CITY OF ALBUQUERQUE

RE: **Lot 3 Block 3 Volcano Cliffs Unit 18 SAD 228**
6608 Cuervo Rd. NW
Grading and Drainage Plan
Engineers Stamp Date 12/31/2020 (D10D003S3)
Pad Certification Date 1/25/2021

Ernest Armijo, P.E.
Principal Engineer, Planning Dept.
Development Review Services

ENGINEER'S SEAL	LOT 3 BLK 3 Un 18 VC 6608 CUERVO PLACE	DRAWN BY DEM
DAVID SOULE NEW MEXICO REGISTERED PROFESSIONAL ENGINEER 14522	GRADING AND DRAINAGE PLAN	DATE 12-30-20
12/31/20	Rio Grande Engineering	6608 CUERVO PLACE.dwg
DAVID SOULE P.E. #14522		SHEET # C1
		JOB #

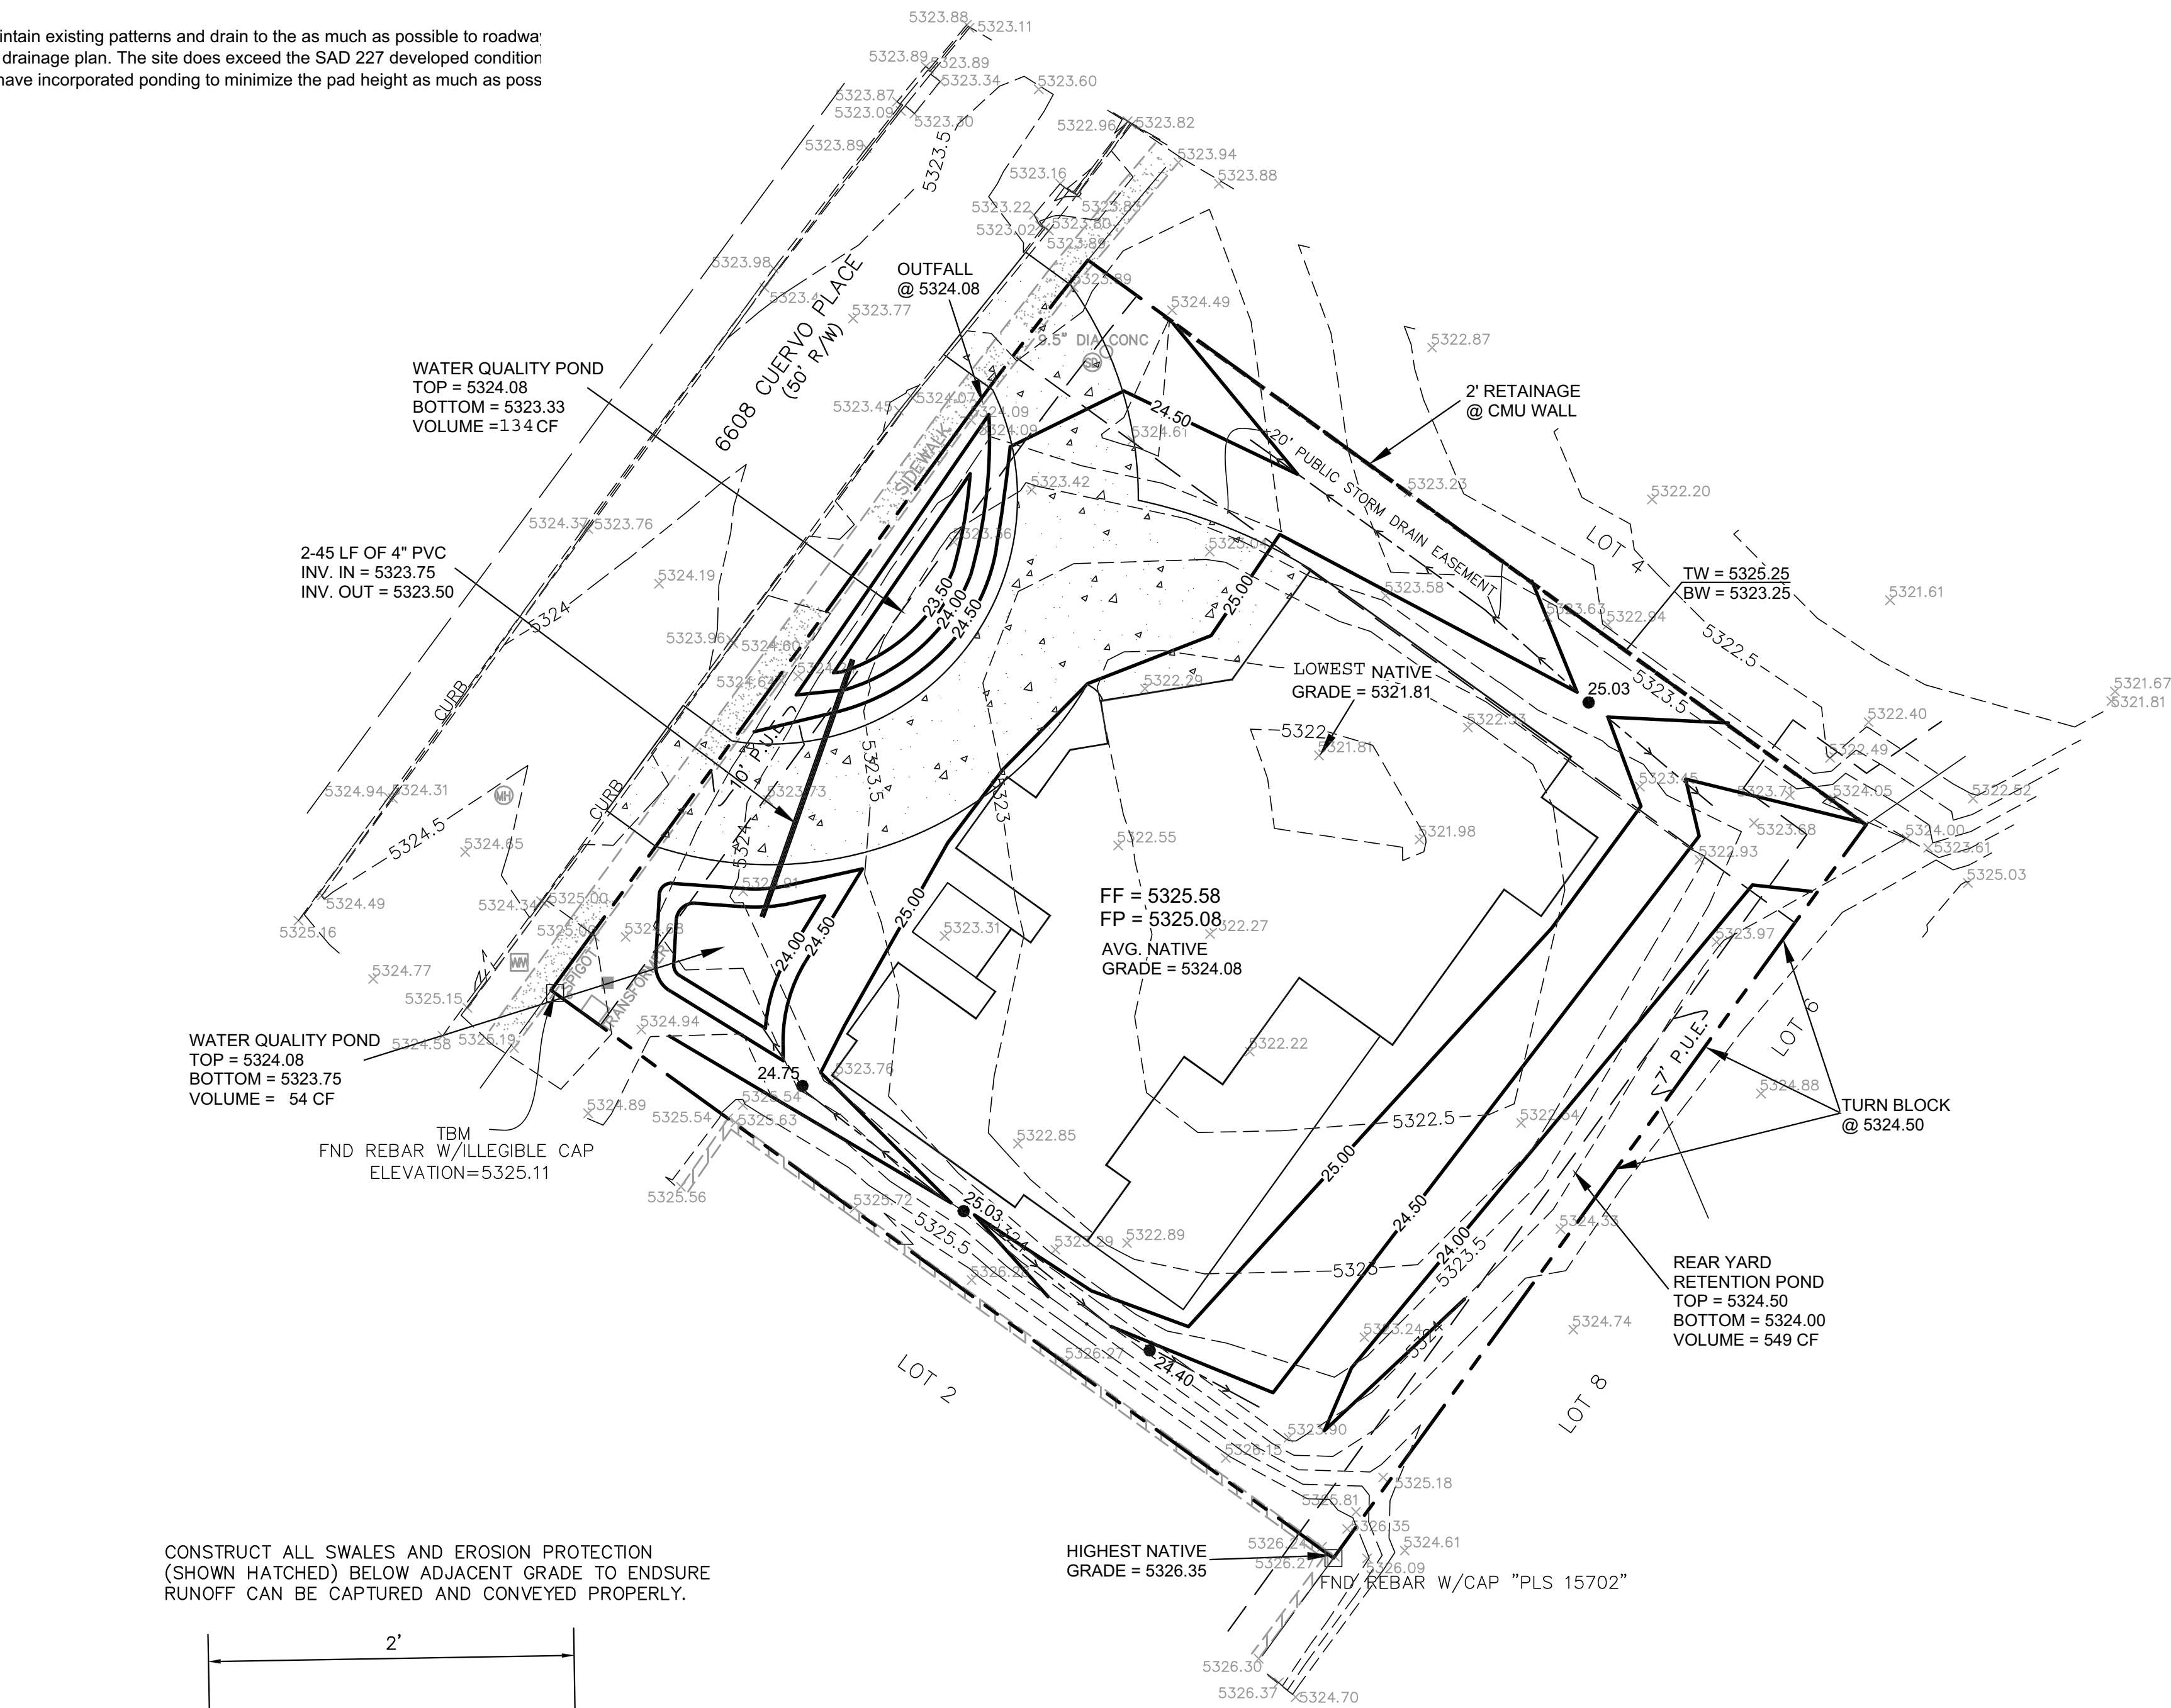
Based upon the information provided in your submittal received 1/26/2021, this plan is approved for Building Permit.

Reiterate to the Owner/Contractor that a separate permit for a garden/retaining wall must be obtained, with the approved G&D plan and Pad Certification. Also, let the owner/contractor know that if a pool is to be added in the future the G&D plan will need to be modified showing the location of the pool and the land treatment differences.

Prior to Certificate of Occupancy release, Engineer Certification per the DPM checklist of this plan will be required.
